## TECHNICAL NEWS SHEET

SERIES V No 322DATE 13.5.52.ISSUED FOR THE GENERAL GUIDANCE OF OPERATORS OF DE HAVILLAND AIRCRAFT AND ENGINES  
OFFICIAL INSTRUCTIONS TAKE PRECEDENCE OVER ANYTHING CONTAINED IN THIS BULLETINVAMPIRE AIRFRAME, GENERAL CIRCULATION.  
SUB HEADING 11, ELECTRICAL EQUIPMENT.Circuit Breakers, Type 'A', Stores Ref. 5C/2559,  
60, 61, 62, 63 and 64. Use with Trip Button  
Covers, Stores Ref. 5C/3610.

VAMPIRE AIRFRAME. GENERAL CIRCULATION.  
SUB HEADING 13. RADIO.

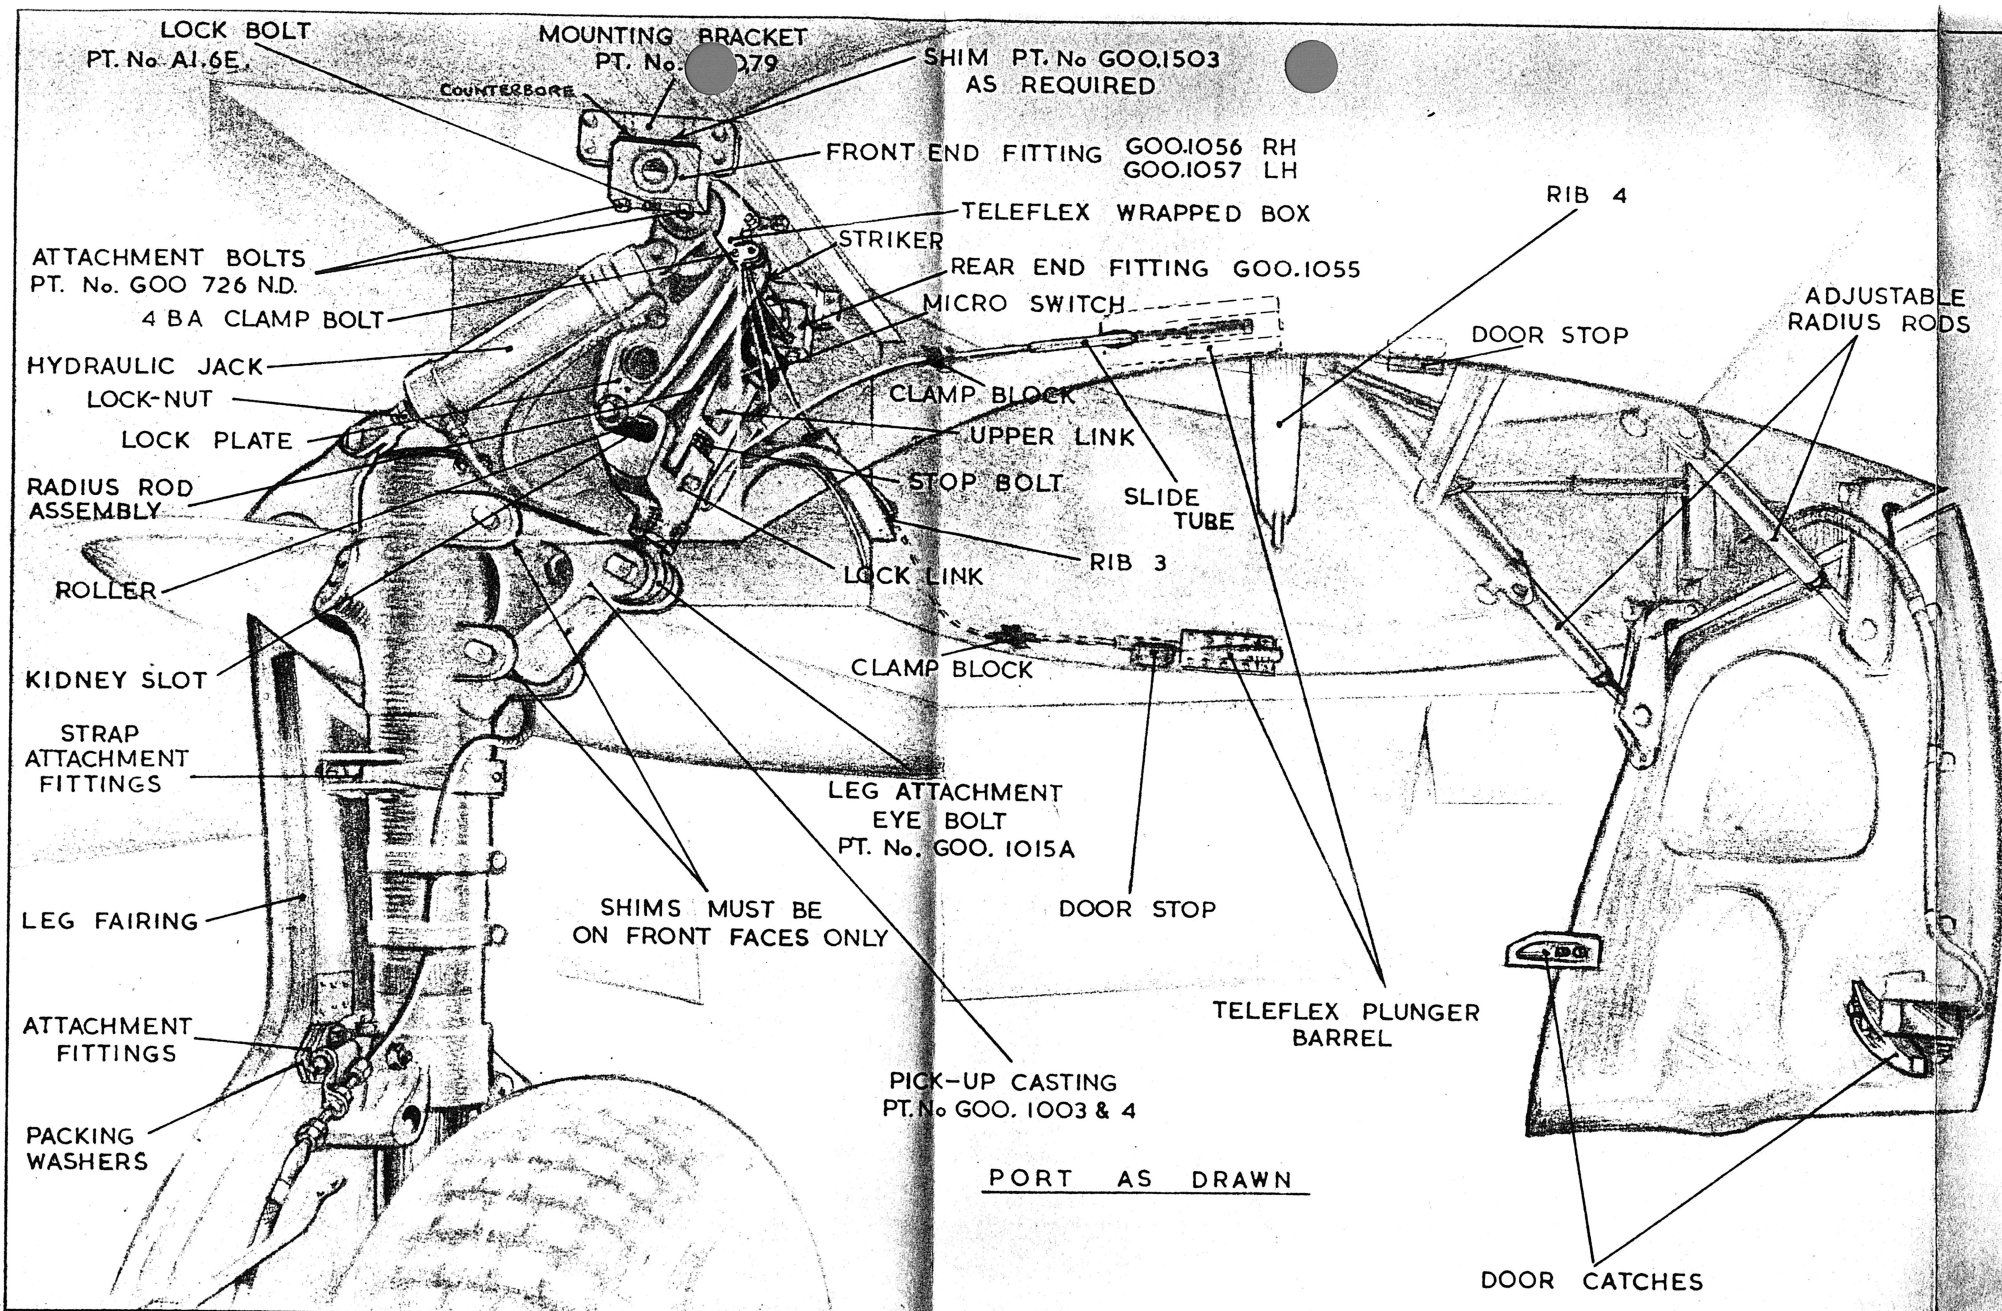
Reports have been received of the 4 B.A. clamp bolt fitted through the wrapped box securing the two conduits, having been tapped into position. As the conduits obstruct the bolt hole, this causes the collapse of the conduits, and in some cases fracturing of the teleflex cable. This is due to the 4 B.A. hole not being cleared by a No. 27 drill prior to the assembly of the bolt.

Undercarriage failures have also been caused by the slide tube fouling the clamp block when the undercarriage is in approx. the  $\frac{1}{3}$  retracted position, this is considered due to poor lock plunger adjustments. S.I. Vampire 41 refers.

1. With the two conduits assembled in the wrapped box, and prior to the fitting of the 4 B.A. clamp bolt, a No. 27 drill is to be passed through the hole.
2. On assembly of the two main lengths of conduits, fore and aft, it is essential that they are adjusted so that they abutt  $\frac{1}{3}$ . If this adjustment is not observed, there is a possibility that the conduit will "bottom" inside the slide tube, causing the teleflex to fracture.

It is recommended that prior to the assembly of the lock plunger and slide tube, that the slide tube is slid over the conduit, and the conduit is marked in the "bottom" position to give a guide on final adjustment of the plunger and slide tube, this mark should be clearly seen with the clamp block in position and the undercarriage approx.  $\frac{1}{3}$  retracted.
